DSA Comments on CEC Draft Report Qualifying Capacity of Supply-Side DR

Comments on CEC Draft Report Qualifying Capacity of Supply-Side DR

Qualifying Capacity of Supply-Side Demand Response Working Group Draft Report

January 2022 | CEC-200-2022-001-CMD

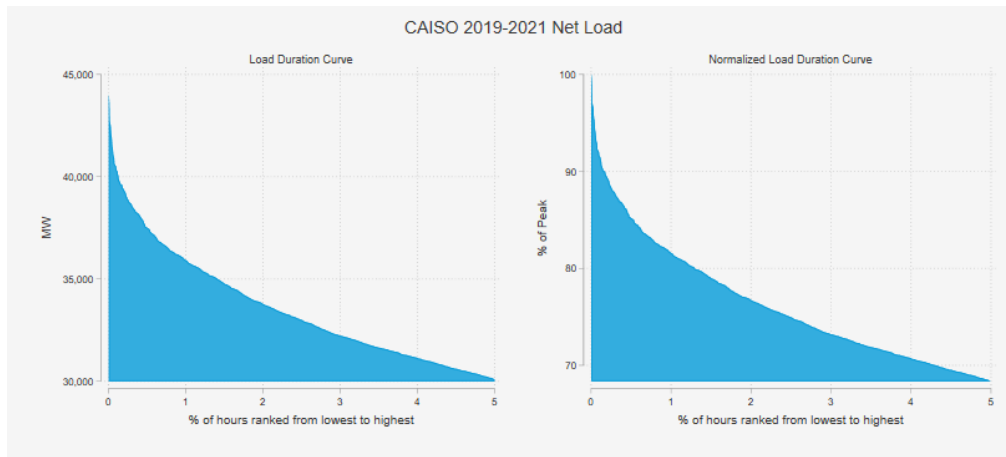
Commented [JB1]: Edited for accuracy. The initial draft made it seem like it is the de facto method, when 2021 was an after the fact test with sample data.

- California ISO demand response program adjustments: Starting in the summer 2021, the California ISO ~~implemented baseline adjustments tested baseline methods through comparison group method changes that relied on matched control groups and changes to the~~ adjustment factors ~~used in the baseline calculations~~ as permitted under the California ISO tariff. This process allowed a more accurate assessment of demand response load reduction during extreme events. The two baseline improvement tracks instituted for the summer included 1) exploring the use of comparison/control group method and 2) establishing a process and criteria for approved use of load adjustment factors outside of the min/max caps for summer 2021. ~~The method has the potential for improving the accuracy of settlements for weather sensitive resources, if it is widely adopted. The approach relies on smart meter data for non-participants and, as a results, concerns about privacy of data and the ability of third parties to replicate the baselines need to be addressed.~~
